Date	August 1, 2018
To	Dealer Principal, General Manager, Service Manager
From	Alta Service Department
SVC-ESB-18-004	SAFETY RECALL CAMPAIGN- Firmware Update – MXR and EXR

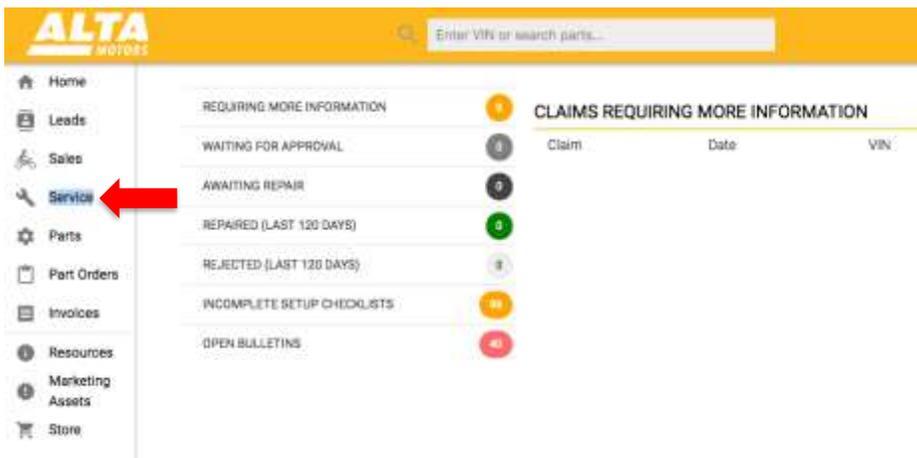
Please take the following steps for updating affected VINs:

1. Verify your Alta Diagnostic laptop is connected to the internet.
2. Plug the laptop into the motorcycle with the diagnostic cable and open the Alta Diagnostic tool on the desktop. Update the Alta Diagnostic tool if needed.
3. As long as the laptop is connected to the internet, the Alta Diagnostic tool will automatically recommend the latest firmware.
4. Once the new firmware is downloaded, verify that the Redshift operates in drive mode and accepts a charge before returning it to the customer.
5. Find the VIN of the machine in the Alta dealer portal, access that VIN's page, follow the prompt to start a claim. This procedure will pay 5 units of labor (half of an hour) to complete.
